Sharmin Apparels Ltd. Sharmin Fashions Ltd. Ha-Meem Washing Plant Ltd. Sharaf Apparels Ltd.

08 April 2014

Observations

Main Garment Factory

Repairs to cracking on soffit of 5th floor

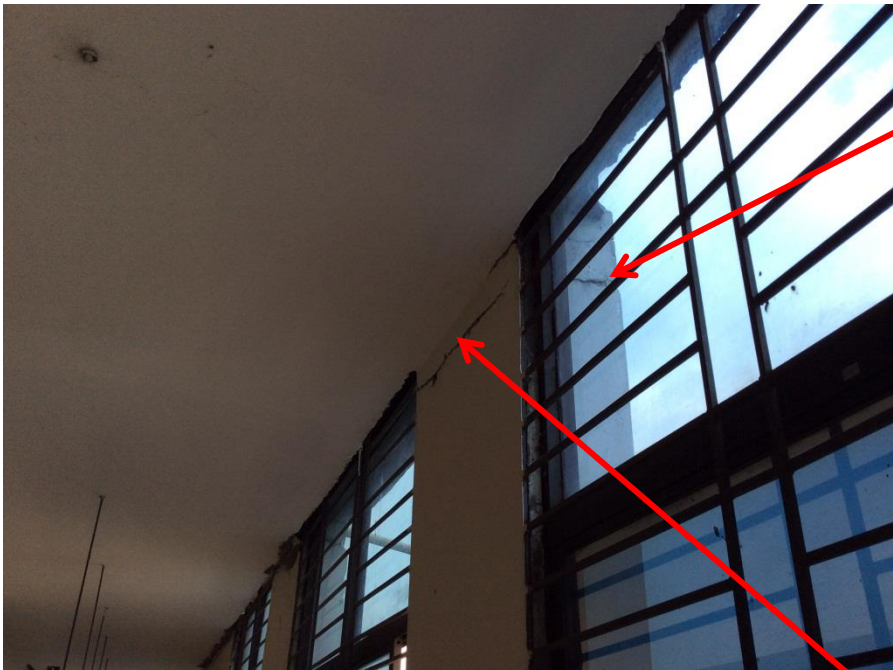
Issues highlighted in BUET Structural Assessment Report

Cracking on ground floor adjacent to column

Building Engineer to carry out a Detail Engineering Assessment including:

- Review of remedial works carried out to date.
- Detailed remedial scheme for any further works, including foundation remedial works, required to ensure that the existing 5 storey building is provided with an adequately robust structural system.
- Documentation of load limitations and preparation of Floor Loading Plans for strict compliance during factory operations.
- Implications of the under-reinforced zones within the post tensioned floor slabs.
- Details of the strengthening works required to the existing structure and foundations if further storeys are to be constructed.

Main Garment Factory - East Elevation

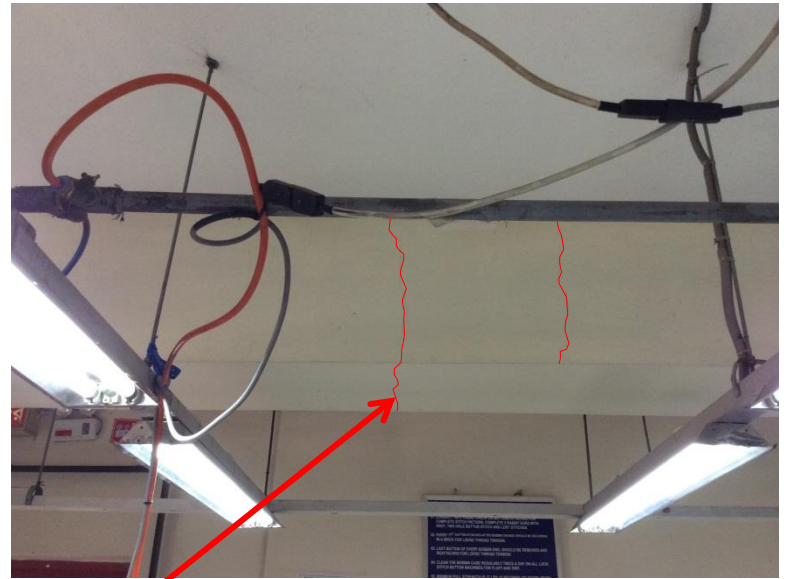
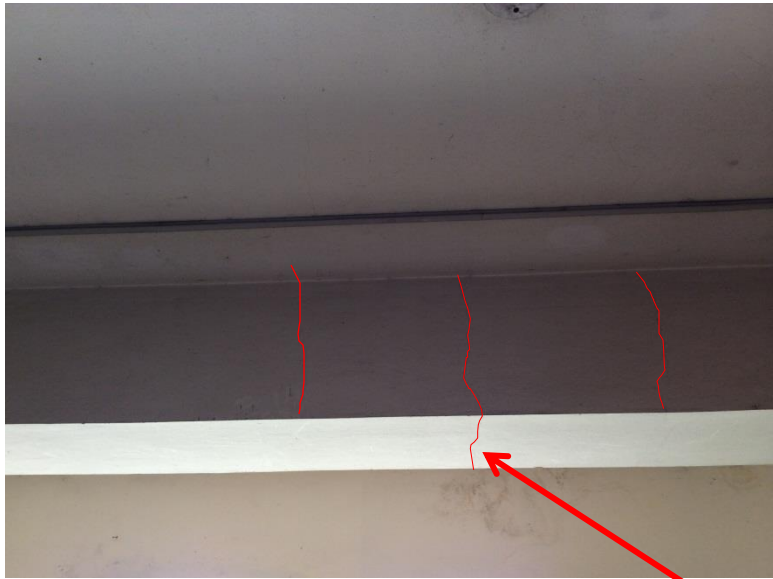
4th floor appears to be deflecting more relative to the 5th floor (roof) causing the pier to separate from the underside of the roof.

**Cracking in the pier
observed throughout**

**Building Engineer to check that the
piers have adequate capacity to
resist lateral loads.**

Cracking in RC Beams

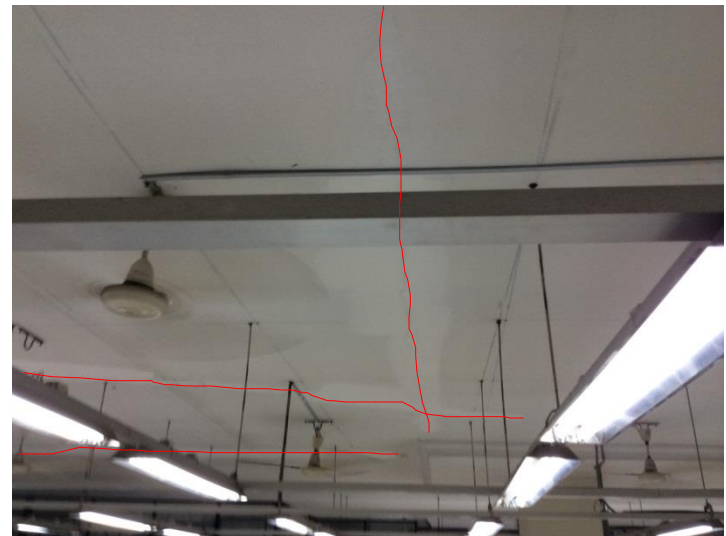
Numerous examples of cracking in RC perimeter beams

Cracking in beams to be reviewed by removing plaster to confirm that cracks do not extend into structure.
